**TOWN OF CARMEL
PLANNING BOARD**

**PLANNING BOARD AGENDA
AUGUST 19, 2020 – 7:00 P.M.**

RE: Carmel Fire Department
94 Gleneida Avenue
Town of Carmel
TM# 44.14-1-24

Re: Carmel Fire Department Site Plan

1" = 60'

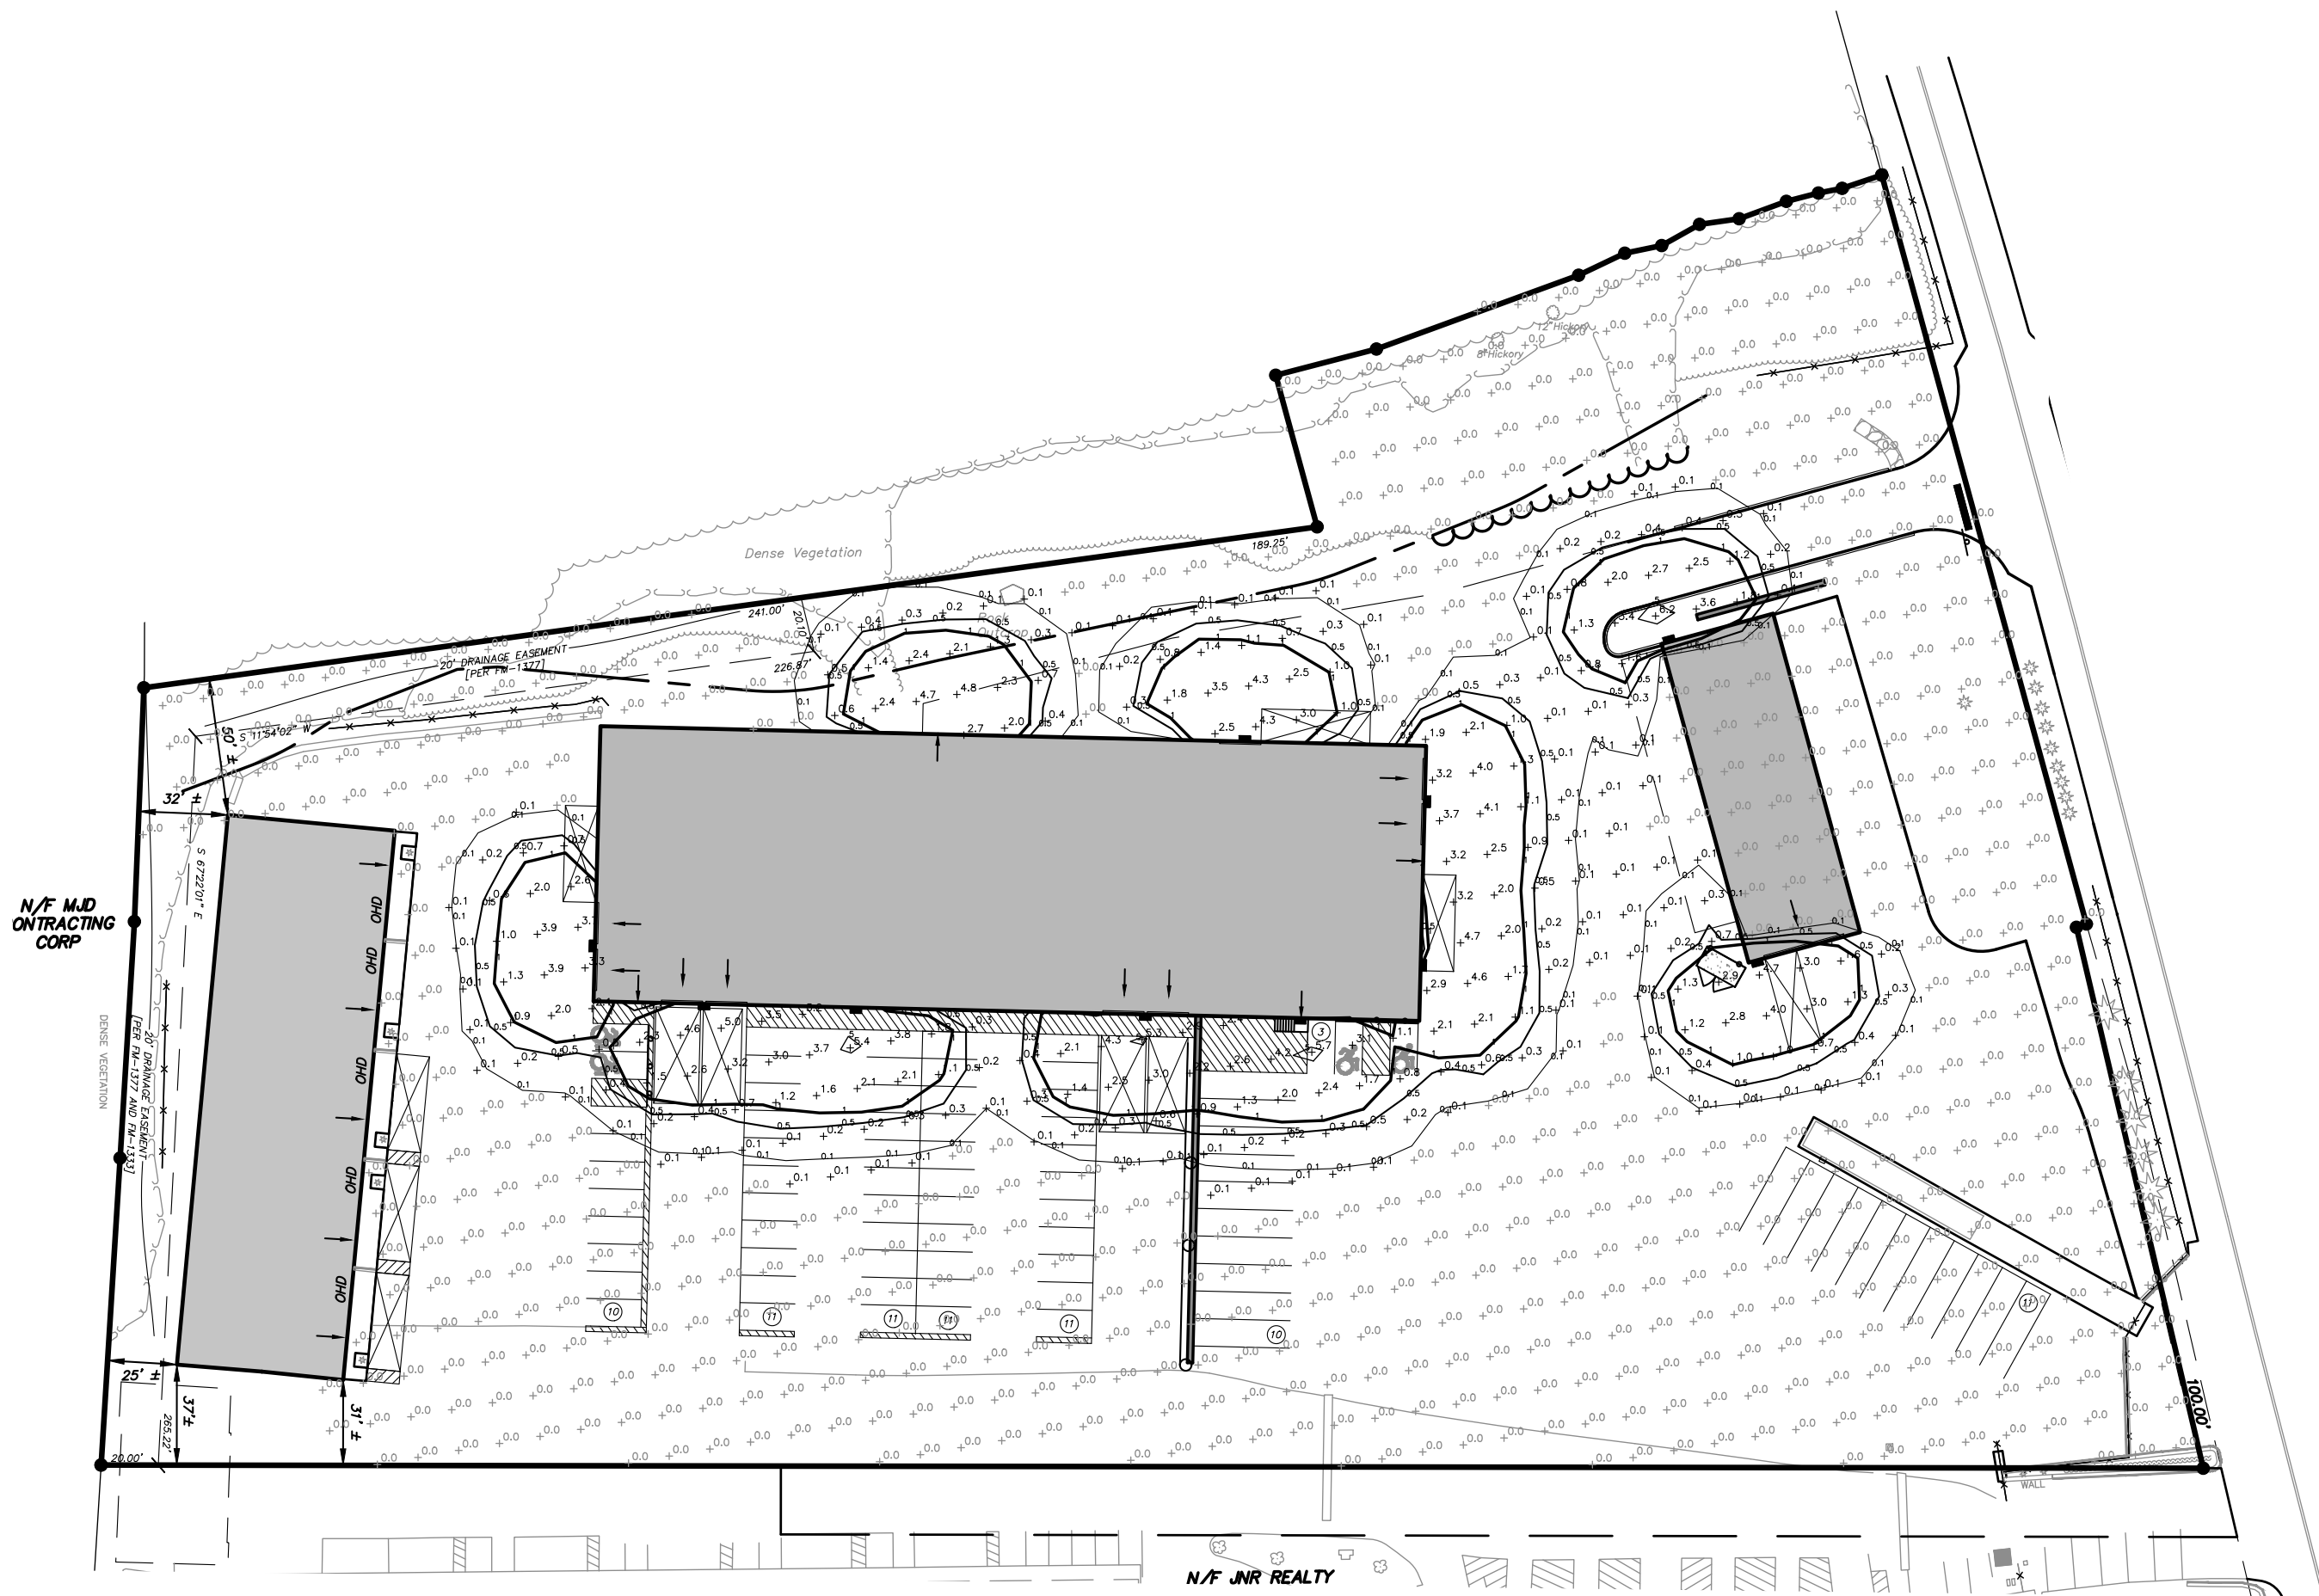
- (4) A Vehicle Maneuvering Plan has been included on sheet SP-4. The plans indicate several maneuvers of a standard WB-62 tractor trailer through the site.

5. A Vehicle Maneuvering Plan has been included on sheet SP-4.
 - a. The plan indicates how a typical WB-62 truck will maneuver through the site.
 - b. A turning radius diagram is provided for the WB-62 on sheet SP-4.
